- MODELS:
- PFM 9.2
 - PFM 9.0
 - PFM900
 - VBG620

● 2002 Dodge 1/2-Ton Truck Update

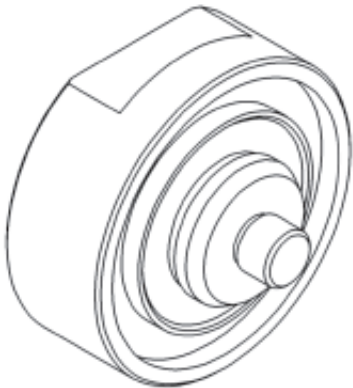
The 2002 Dodge 1/2-Ton Trucks have larger lug nuts that interfere with our adapter, 50-691 rev 7.

The studs have a slight shoulder on them. A 30-791 spacer (left) is required so that the adapter sits flush.

The gearbox interferes with the rotor. A 50-046 nose cone spacer (left) is required to space out the gearbox. Do not under any circumstances grind down lathe or gearbox body!

The pattern is the same, 5 on 5.5". An after market lug nut is required. Size: 9/16" x 18-stud 7/8" hex. The Pro-Cut lug nut kit now contains these lug nuts (red colored; part #50-179).
